CONSTRUCTION PLANS

Cell 4-AB

Re: OWL NDBL SWMF Cell 4-AB Construction Plans
Document Received 4/20/2022

OWL NDBL SWMF
CELL 4AB
CONSTRUCTION PLANS

LANDFILL
SUBGRADE
CROSS
SECTIONS

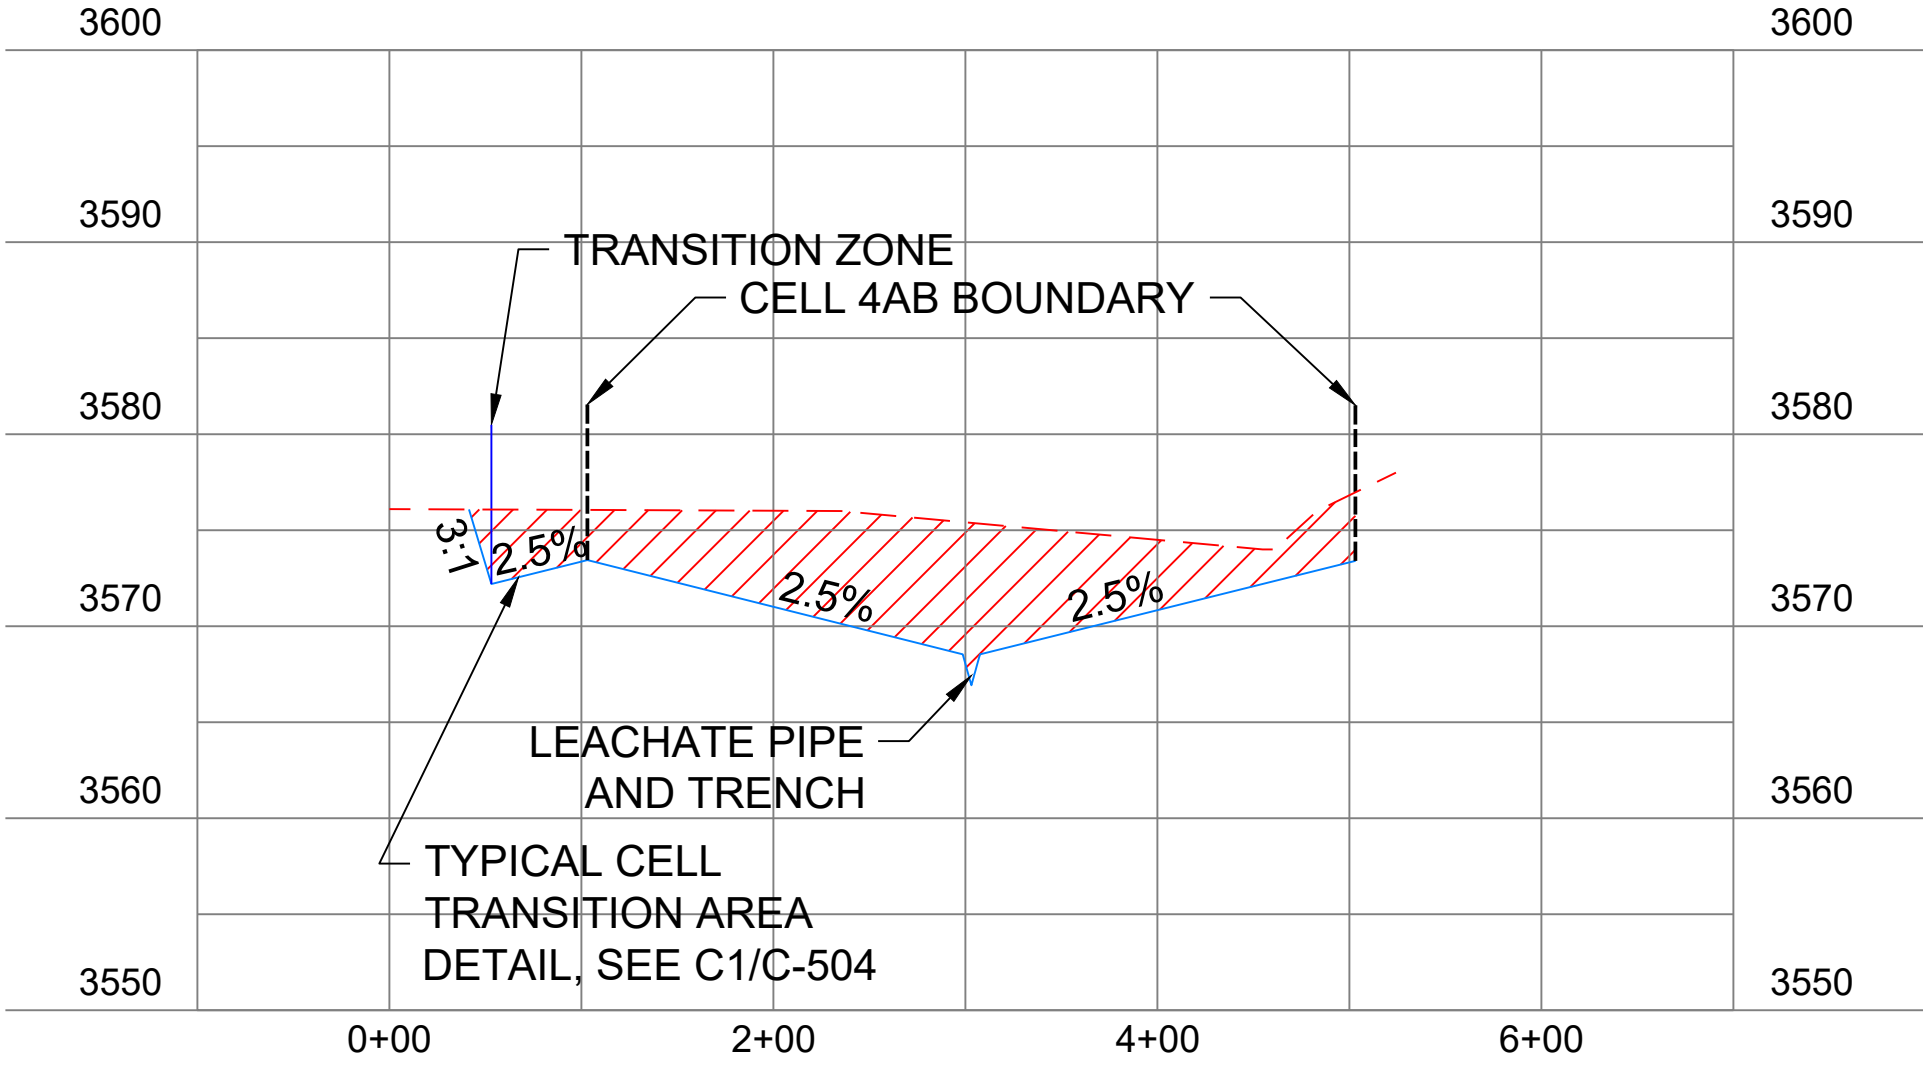
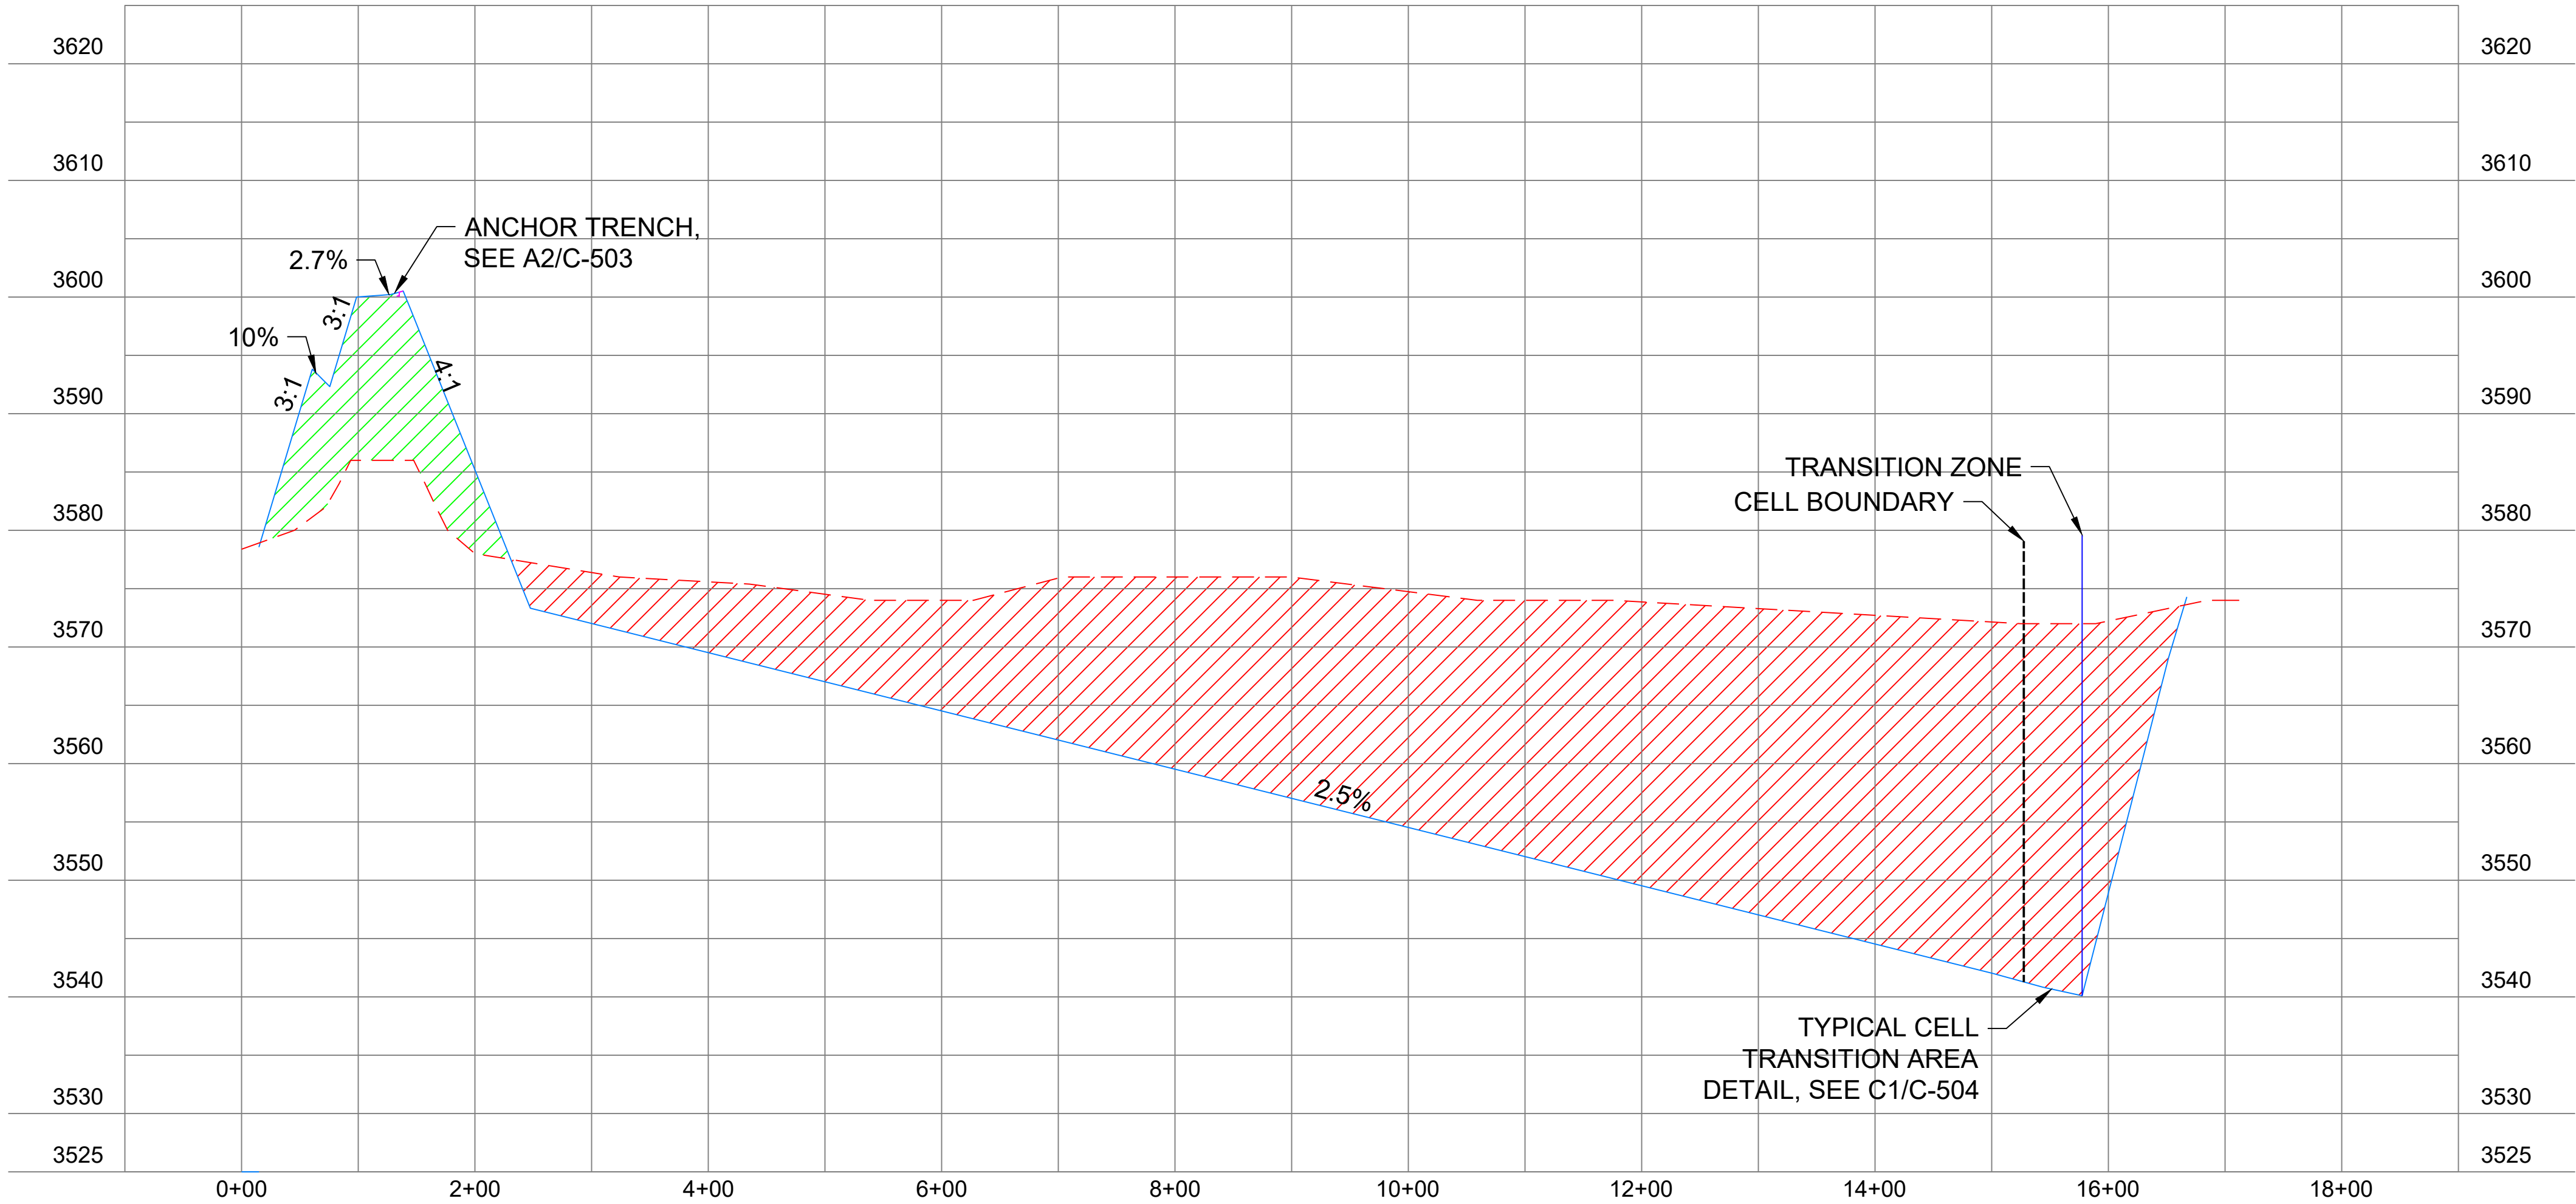
As stated the multi-layered liner system for cell bottom and sideslope is the same as approved for Cells 2-AB and 3-AB. Inside cell slope is 3H:1V, except for the northern portion of the cell at 4H:1V. This section of Cell 4-AB has a compacted berm fill with an

outside slope of 3H:1V. The plans show about 20 ft of vertical fill required. The plans do not indicate a specified compaction density for this berm construction. However, the anchor trench constructed at the top of the berm fill specifies a 90% standard proctor dry density. Cut-fill estimates based on the cut-fill tic plan (Sheet C-104) indicates a net soil volume balance, more than sufficient to construct the northern berm. L-shaped liner anchorage is typical per industry standard and compliant with regulatory requirements. The specified bottom cross-slopes provided on the subgrade grading plan for Cell 4-AB meet the minimum liner slope of 2.8 % specified in Vol I of the 2016 Application. Compaction for the subgrade and is specified at 90 % standard proctor dry density.

B1 LEACHATE COLLECTION TRENCH AND PIPE
NOT TO SCALE SECTION VIEW

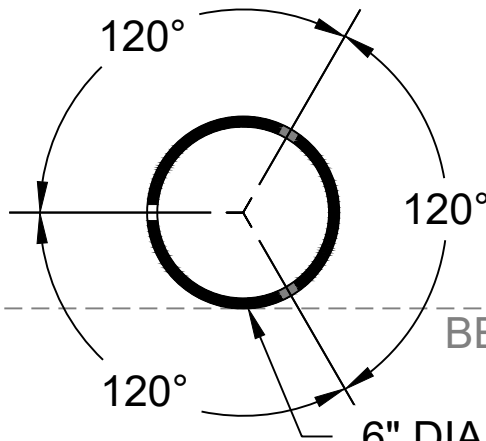
The leachate collection trench at 2.5 % exceeds the minimum prescriptive slope requirement of 2 %. Leachate collection trench and piping as well as cleanout riser and trench are typical per industry standard and are compliant with prescriptive regulatory requirements. A 2 ft protective soil layer over the double composite liner system meets the prescriptive depth requirement. A saturated hydraulic conductivity of greater than or equal to 4.2×10^{-5} exceeds the prescriptive requirement.

TYPICAL CELL TRANSITION AREA

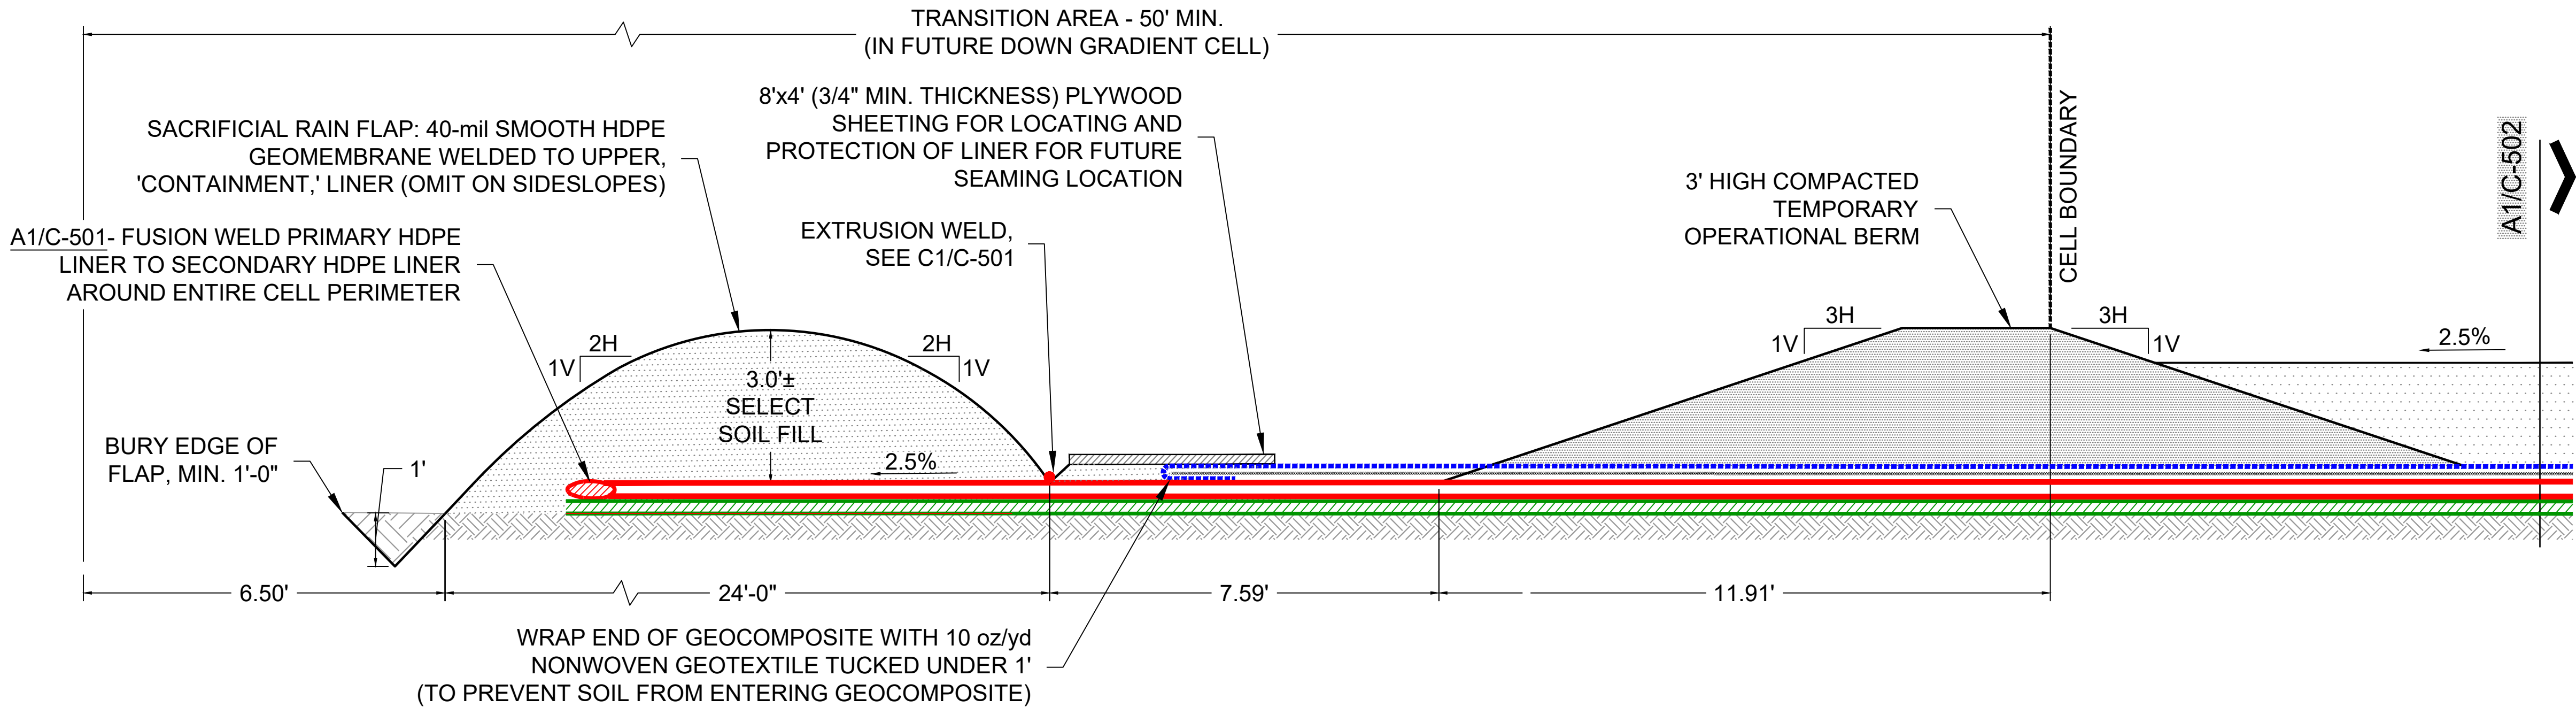
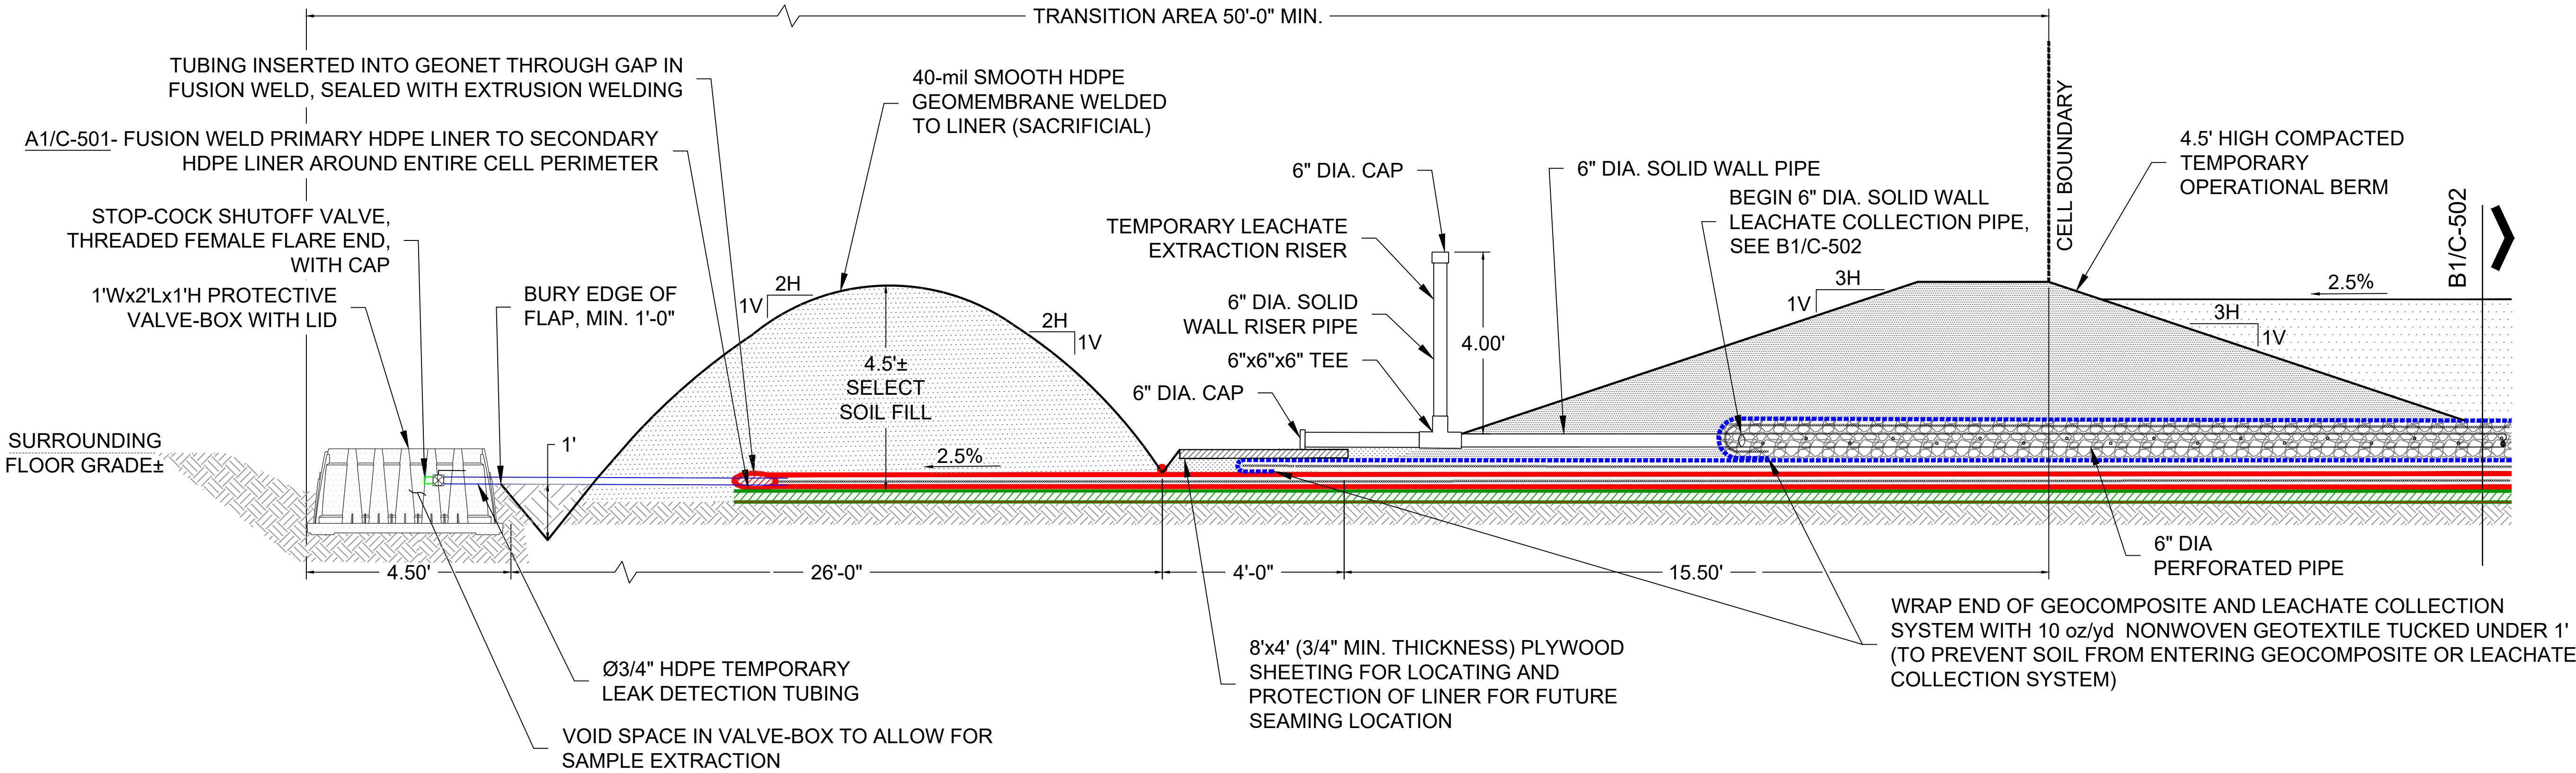
Cell transition details for Cell 4-AB to the west and east at the lower portion of Cell 3-AB are typical per industry standard and are compliant with prescriptive regulatory requirements. A temporary sump for leachate extraction and leak detection was provided at the south end of Cell 4-AB for tie-in downgradient. These details are typical per industry standard and are compliant with prescriptive regulatory requirements. Easy access to leachate extraction and monitoring of leakage through the primary barrier layer is facilitated with the design provided.
